RE: EMERGENCY PREPAREDNESS PLAN REVISION, PSU BREAZEAL REACTOR (LICENSE R-2,
DOCKET 50-005)

Table of Changes to PSU Breazeale Reactor Emergency Preparedness Plan, Rev. 5 (2021)

PENN STATE BREAZEALE REACTOR (PSBR)
EMERGENCY PREPAREDNESS PLAN

REVISION 5

Figure 3.1

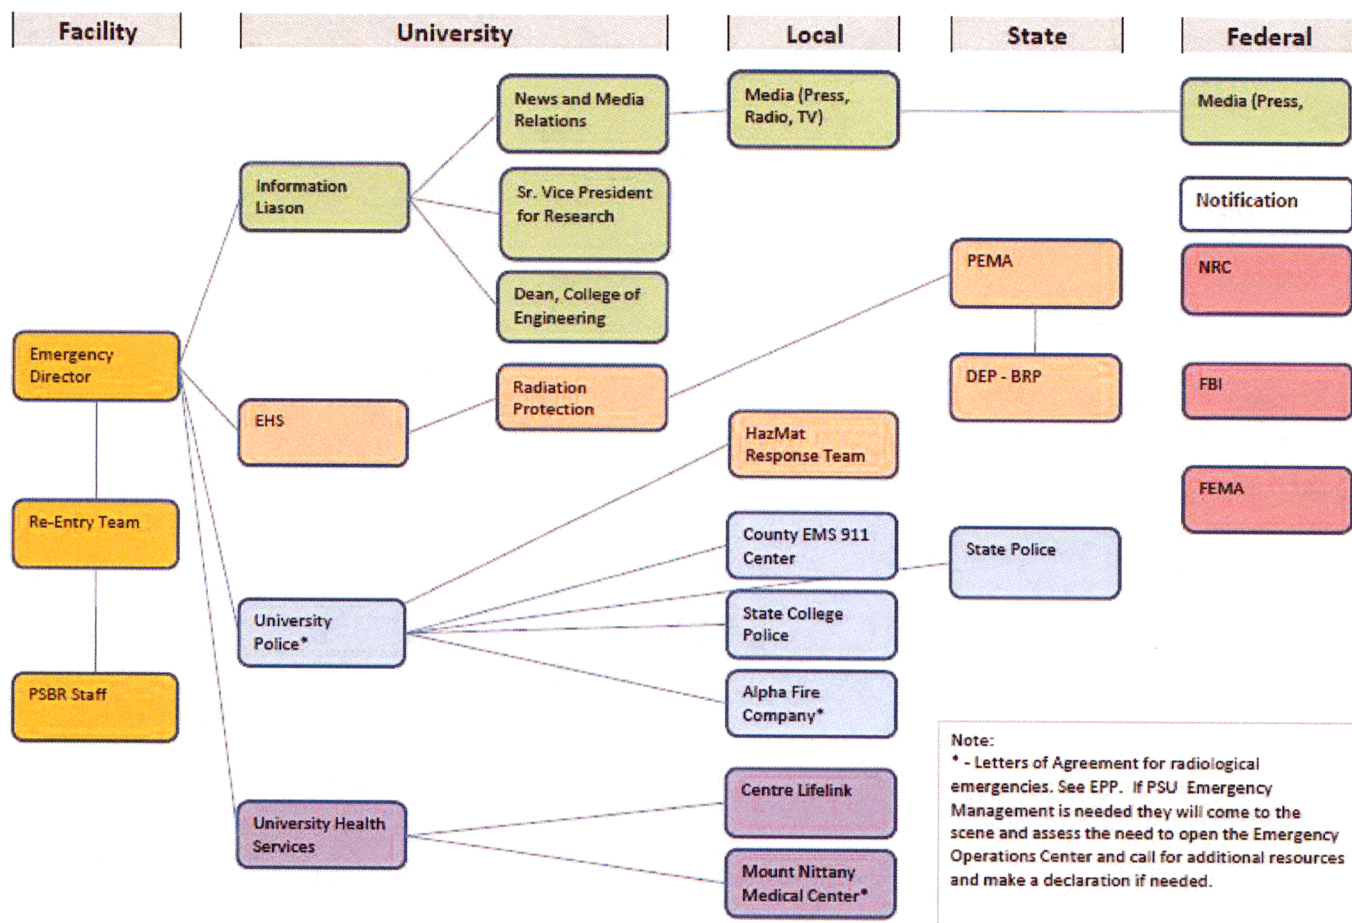
Change	Section	Description
1	1.1, 2.6	Updated reference version of ANSI/ANS 15.16 to reflect the most current guidance and corrected the pertinent section of AEA Section 104 from (b) to (c) .
2	1.2	Included a reference to 50.54(x) guidance to clarify that deviations from the license conditions or technical specifications are allowable when immediately necessary to protect the health and safety of the public.
3	throughout	Minor grammatical / editorial updates
4	1.3	Updated title of Level 1 management in license.
5	Fig 1.2	Updated reactor site figure to include planned changes to building footprint and outbuilding locations.
6	1.3	Updated description of neutron beam lab, which has been modified since the last EPP revision.
7	1.3	Updated description of the Co-60 irradiation facilities
8	3.1	Updated names of organizations in the Emergency Organization section.
9	Fig 3.1	Updated Emergency Organization chart.
